# Industry proposal False reaction scenario

AEBS-HDV-07

October 26-28, 2021

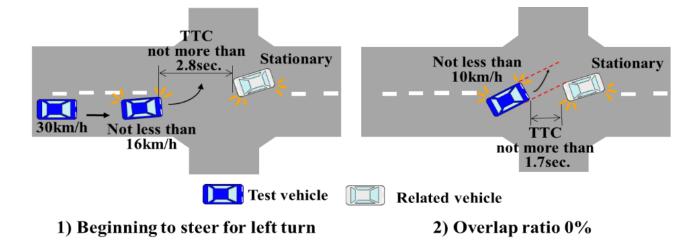
# Scenario 1 is not relevant for some HDVs (e.g. M3>8t, N2>8t N3)

(Furthermore, it looks not in accordance with driving licence rules in some countries).

Could this scenario be deleted for the heaviest categories?
